Proposed Updated Final Safety Analysis Report Tables and Figures
(Mark-Ups; for Information Only)
(164 pages follow)

FINAL PLANT LAYOUT, PLAN C ABOVE
ELEVS. 620'-6", 623'-6" AND
624'-6", PLANT COMPLEX
FIGURE 1.2-5
(DWG. E-013-0005-00000)

PLAN-LOCATION OF LAKE ERIE
SHORELINE AND BLUFF RECESSION
SURVEY LINES
FIGURE 2.4-32

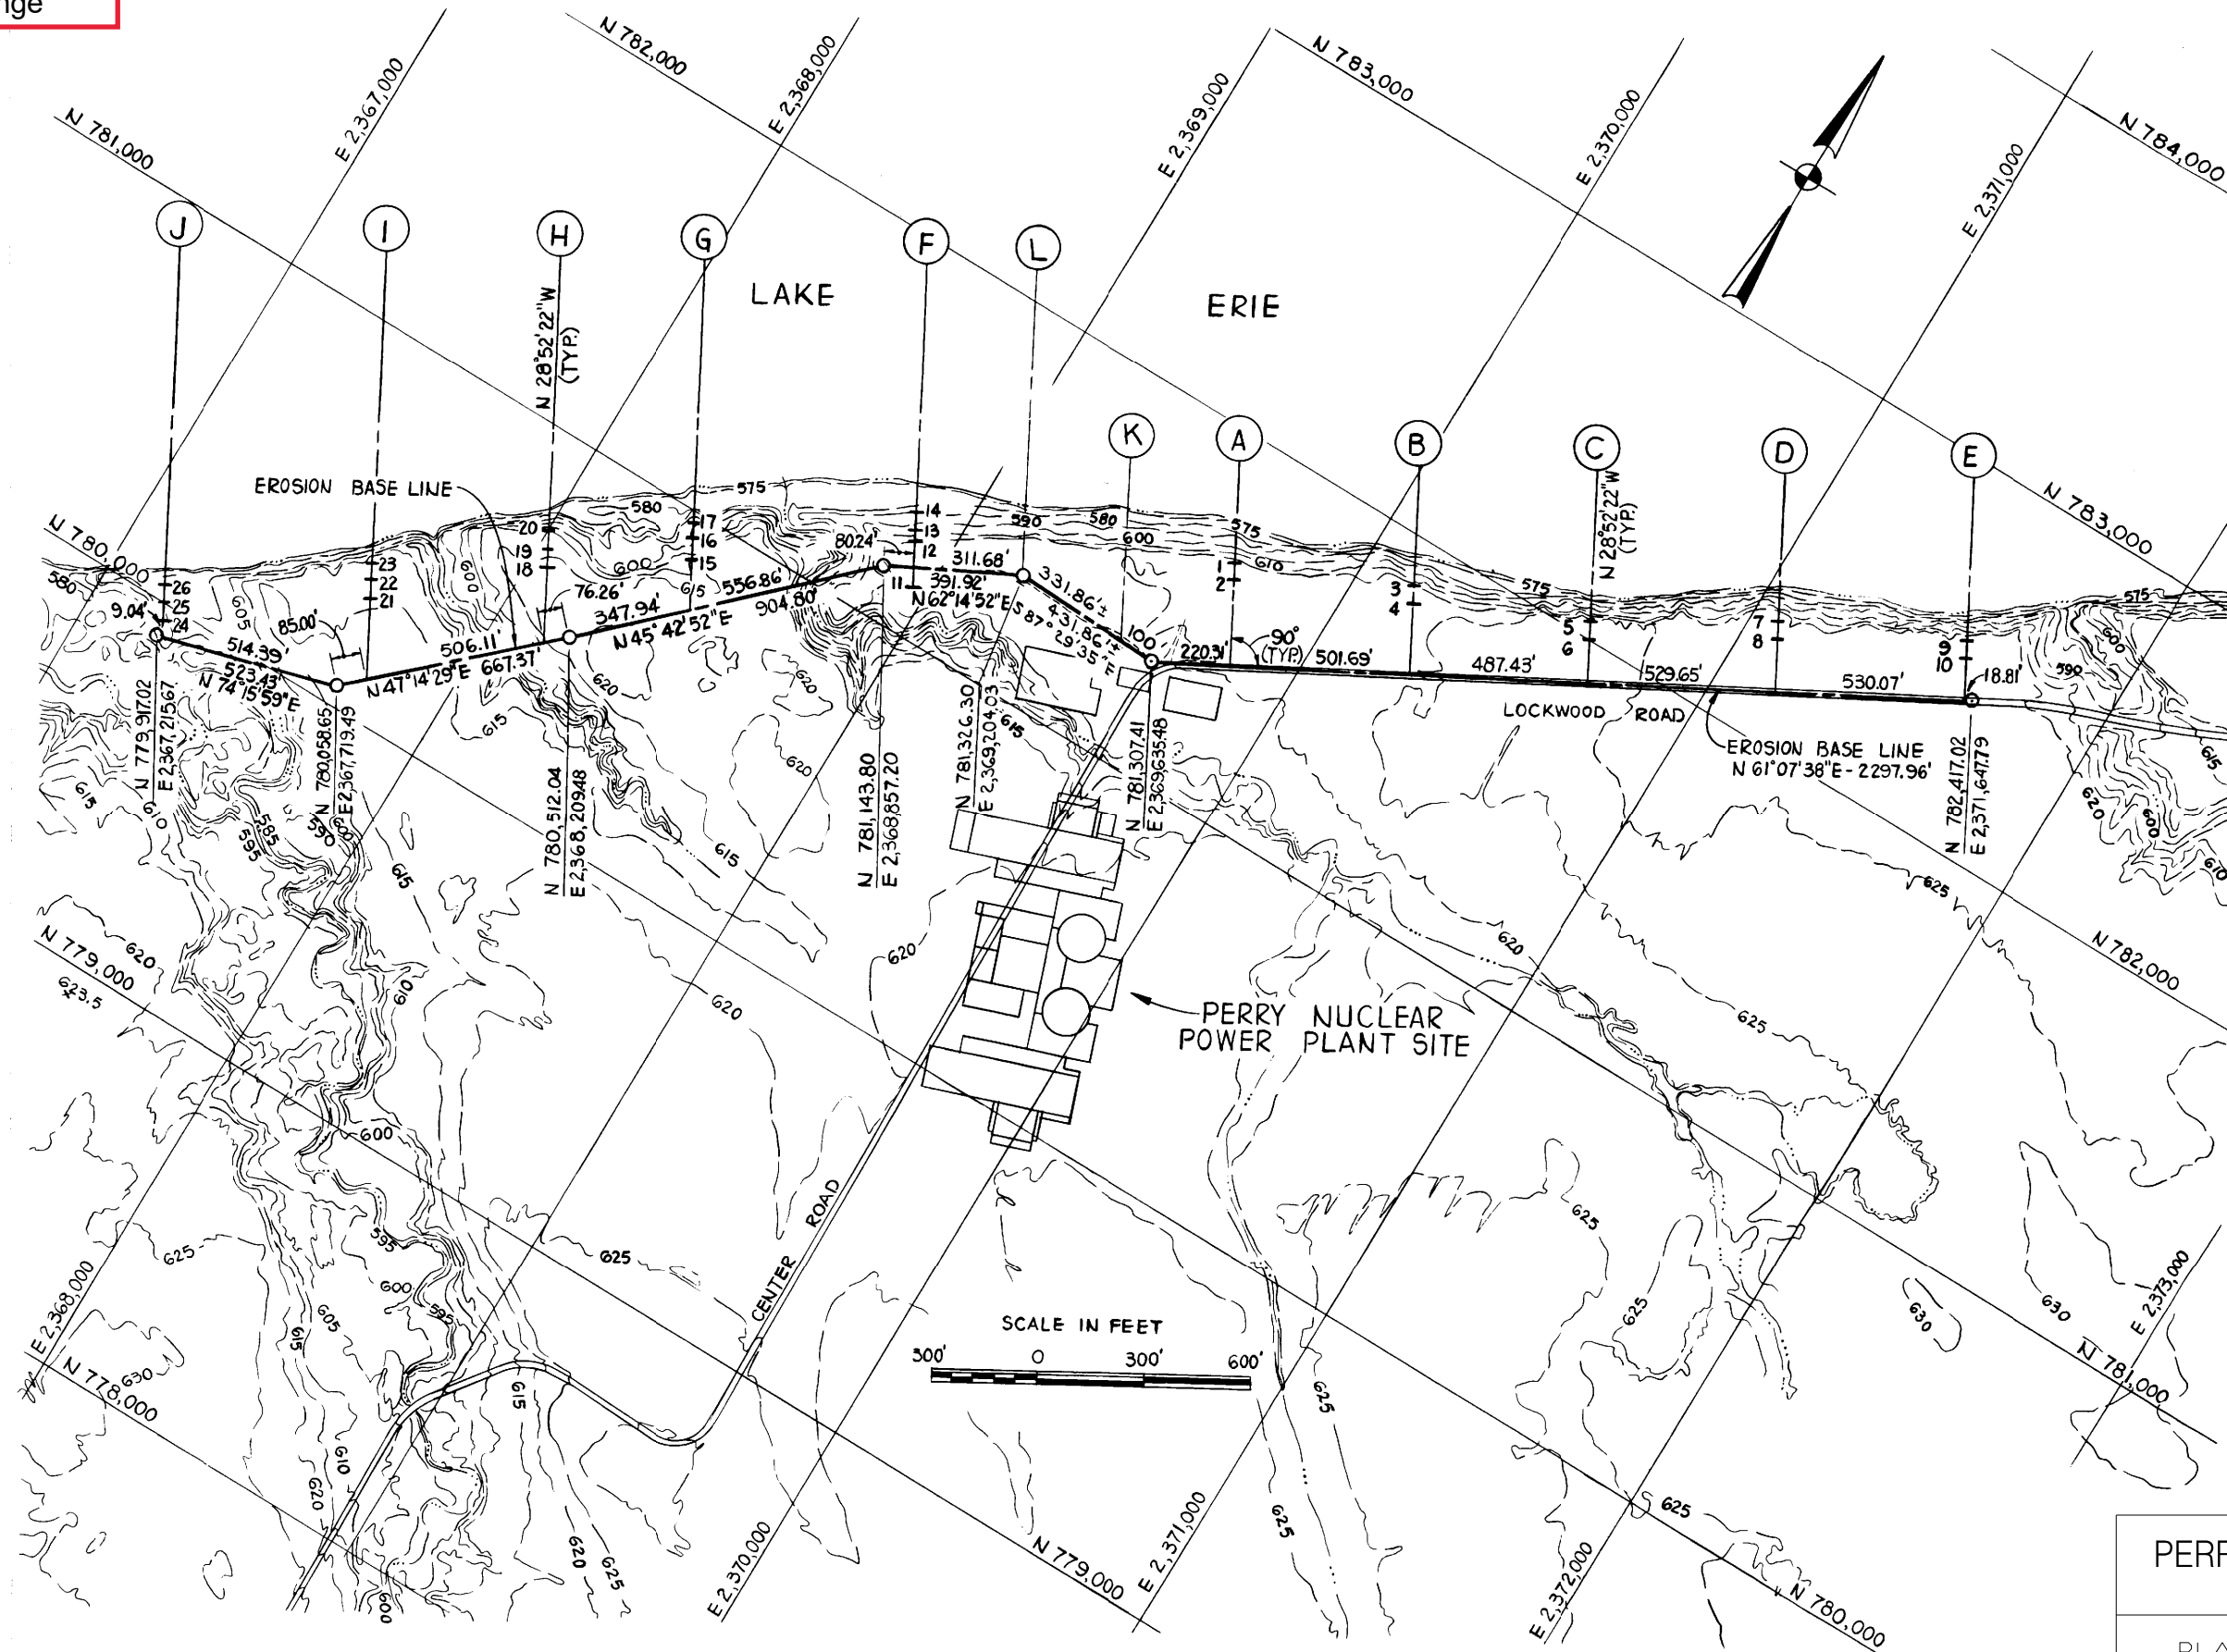
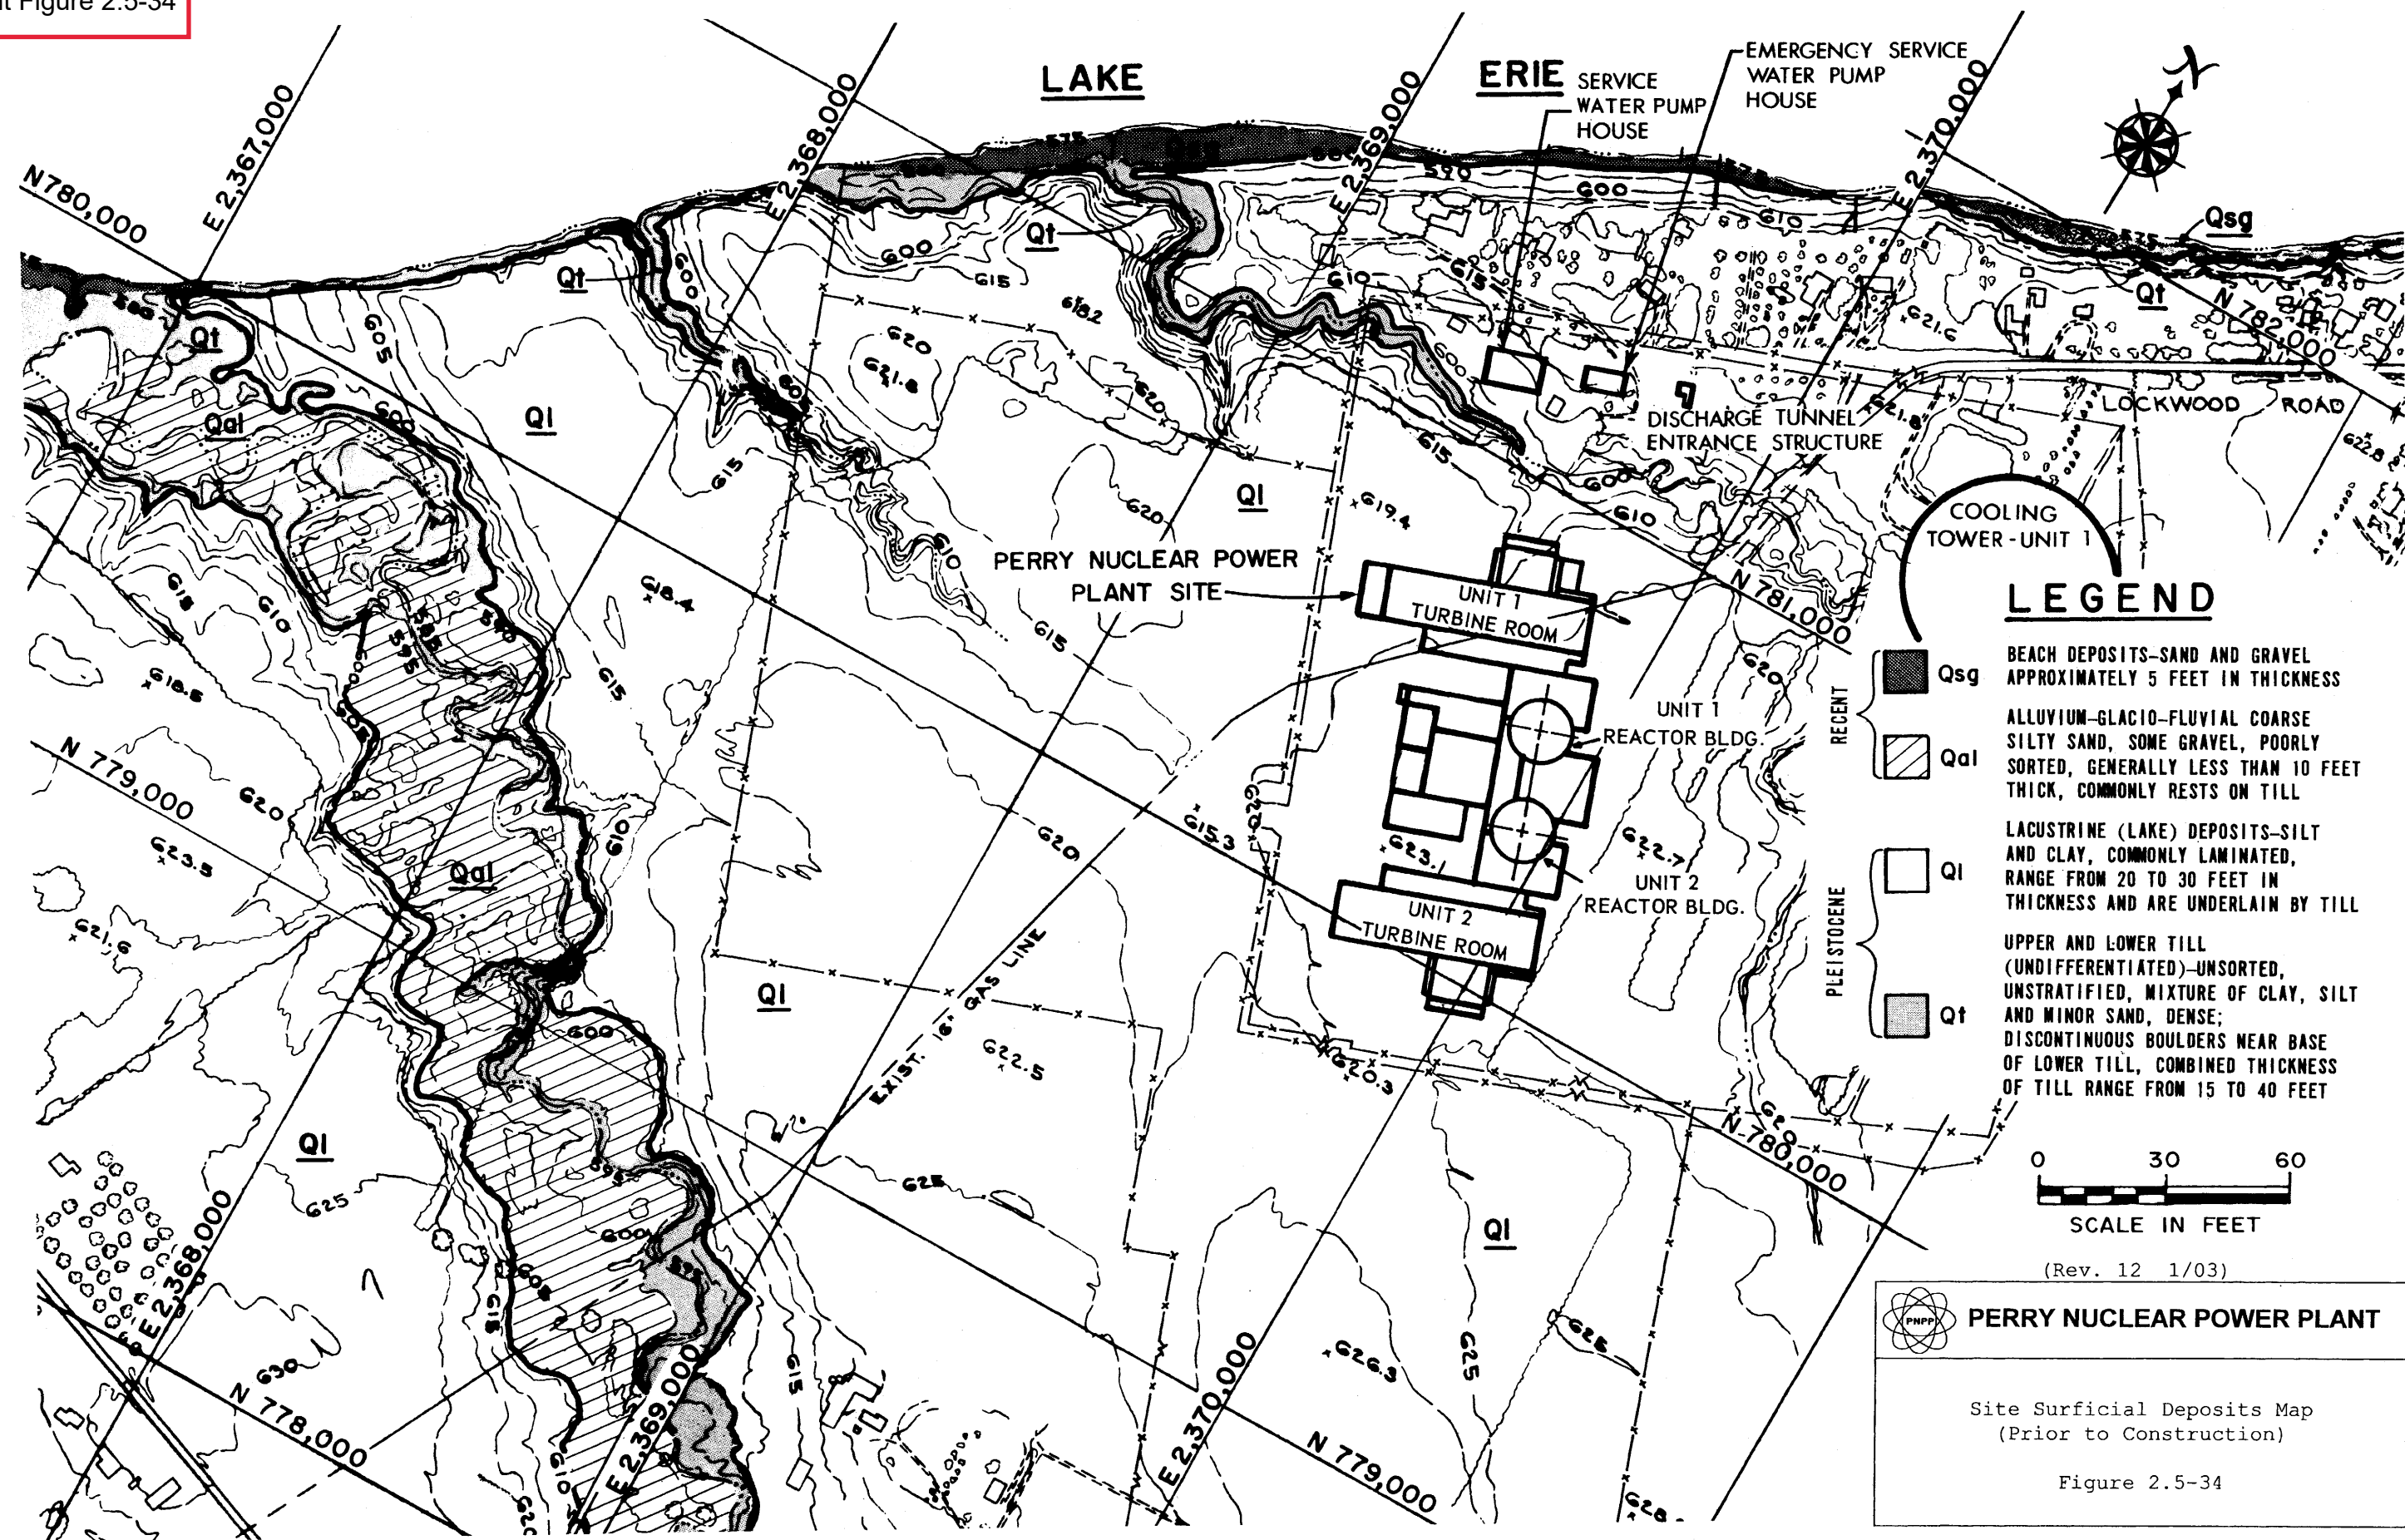
ADD NOTE
THIS CN

NOTE:
THIS USAR FIGURE CONTAINS HISTORICAL
TOPOGRAPHICAL INFORMATION FOR REFERENCE
ONLY AND WILL NOT BE UPDATED.
